WASHINGTON PUBLIC POWER SUPPLY SYSTEM

Subject: **WNP-2, OPERATING LICENSE NPF-21  
REQUEST FOR AMENDMENT  
TECHNICAL SPECIFICATION SR 3.8.1.8  
ADDITIONAL INFORMATION**

Reference: Letter GO2-98-215, dated December 17, 1998, GO Smith (SS) to NRC,  
"Request for Amendment - Technical Specification SR 3.8.1.8"

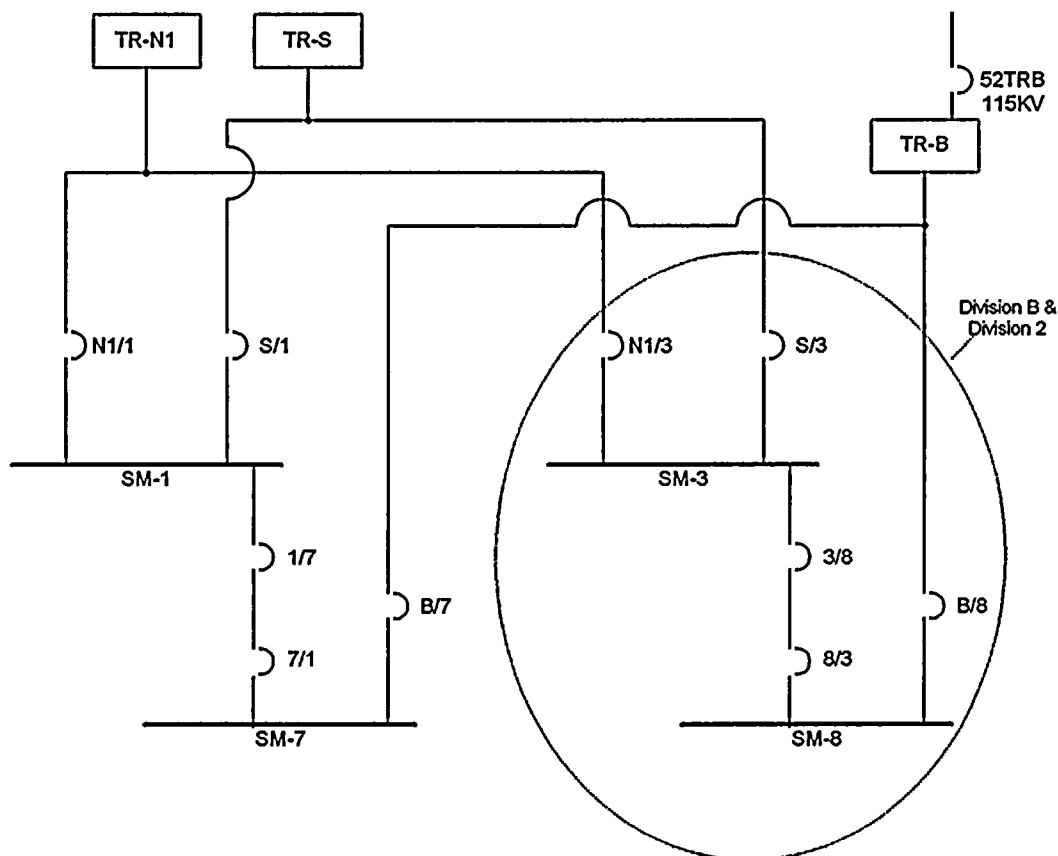
The surveillance is currently modified by a restriction in the form of a note which states that the automatic and manual transfer portions of the surveillance shall not be performed while in Modes 1 and 2. During follow-up discussions, the staff raised questions regarding the risk aspects due to transients that could potentially be induced by the manual transfer. Specifically, the staff questioned the possibility of a circuit breaker fault and its impact on the safety buses. 11

The proposed amendment would allow the manual transfer of SM-7 from preferred source SM-1 to alternate source TR-B, or transfer of SM-8 from preferred source SM-3 to alternate source TR-B when required for equipment testing. To address the staff's questions pertaining to the potential for increased risk due to transients induced by the transfer, an analysis was performed to define the initiating frequency for such a transient.

For ease of discussion, the following figure is included and represents a description of the Division 2 (Division B) electrical distribution scheme associated with a manual transfer between the preferred and alternate offsite power sources. The logic scheme and circuit breaker operation are identical for Division 1 (Division A).

During normal operation, circuit breakers 3/8 and 8/3 are closed and circuit breaker B/8 is open. When the manual transfer is performed, breaker B/8 closes and breaker 8/3 opens. If breaker B/8 fails to close, there is no transient because of the physical arrangement of the breaker logic. Contacts on breaker B/8 initiate the opening signal logic for breaker 8/3. Accordingly, if breaker B/8 does not physically close, there would be no signal to open breaker 8/3.

However, possible problems could occur if breaker B/8 closes and breaker 8/3 fails to open. If breaker 8/3 fails to open and results in a high cross connect current or fault between phases condition, either breaker B/8 or breaker 3/8 should open. Both breakers are designed to open on an overcurrent condition. If 8/3 fails to open and both B/8 and 3/8 subsequently fail to open, then it is possible for SM-8, SM-3 and TR-B to be isolated when breakers S/3 and 52TRB open to isolate the fault. The initiating frequency and conditional core damage probability for this set of failures has been calculated and is presented in the following Case 1 discussion.

If breaker S/3 fails to open, coupled with the simultaneous failure of breakers 3/8, 8/3 and B/8, then TR-S could be isolated as well. Therefore, this scenario results in the loss of SM-8, SM-3, TR-B and TR-S. The initiating frequency and conditional core damage probability has been calculated for this set of failures and is presented in the following Case 2 discussion.

This case consists of the failure of circuit breakers 8/3, 3/8 and B/8 to open. A failure of breaker 8/3 to trip following a manual closure of breaker B/8 could potentially result in paralleling of 230 kV and 115 kV sources for a sustained period. If the power flow between the two offsite sources results in a current in excess of the protective relay trip setting, breaker B/8 and/or 3/8 would trip, isolating SM-8 from one or both offsite sources. If the power flow between the two offsite sources results in a current less than the protective relay settings, then the control room operator could manually trip breaker 3/8 or breaker B/8 to isolate SM-8 from one of the offsite sources. If the current is less than the protective relay settings, no damage or transient occurs, even though all three breakers fail to open. This risk assessment conservatively assumes that the current after breaker 8/3 fails to open will always be sufficient to damage equipment if a breaker is not opened (i.e., phase-to-phase or three-phase internal fault at breaker 8/3).

An over current condition is sensed separately at each of the three breaker locations. The logic is designed such that over current conditions sensed at breaker 8/3 results in a trip signal to all three breakers. Over current sensed at breaker 3/8 results in a separate trip signal to breakers 8/3 and 3/8. Over current sensed at breaker B/8 results in another trip signal to breakers 8/3 and B/8. The sensing circuits are separate from the relays so that the failure of breaker 8/3 to open does not result in failure of the over current protection logic for that breaker.

A fault tree was constructed to determine the initiating frequency for a transient caused by the loss of these three breakers. The fault tree included the following failure modes: 1) mechanical failure of the breaker to open when required; 2) trip logic relay failures; 3) over current sensing relay failures; 4) loss of DC power to the logic circuits; and 5) common cause failure of the three breakers (which are identical in model and manufacturer). The fault tree probability is heavily dominated by the common cause failure probability of the three breakers.

With SM-3, SM-8 and TR-B out of service, the conditional core damage probability was determined to be  $1.61E-3$ . Therefore, the contributions of core damage frequency calculated from the event tree for this scenario is  $5.33E-7$  ( $= 3.31E-4 * 1.61E-3$ ).

With SM-3, SM-8, TR-B and TR-S out of service, the conditional core damage probability was determined to be 0.11. Therefore, contributions of core damage frequency calculated from the event tree with these components out of service is  $2.93E-7$  ( $= 2.66E-6 * 0.11$ ).

Accordingly, the sum of the events from the postulated manual switching initiator is  $8.26E-7$  or 4.7 percent of the current Level 1 PSA core damage frequency. This is an acceptable risk based on EPRI/NEI PSA Applications Guide EPRI TR-105396.

Based on the transient analysis, we determined that making the manual transfer less than 50 times a year does not pose an unacceptable risk increase. We also found that the common mode failure event heavily dominates the initiating frequency. However, the trip logic and breaker location design is failure tolerant and the contribution to risk from random failure during manual switching is negligible.
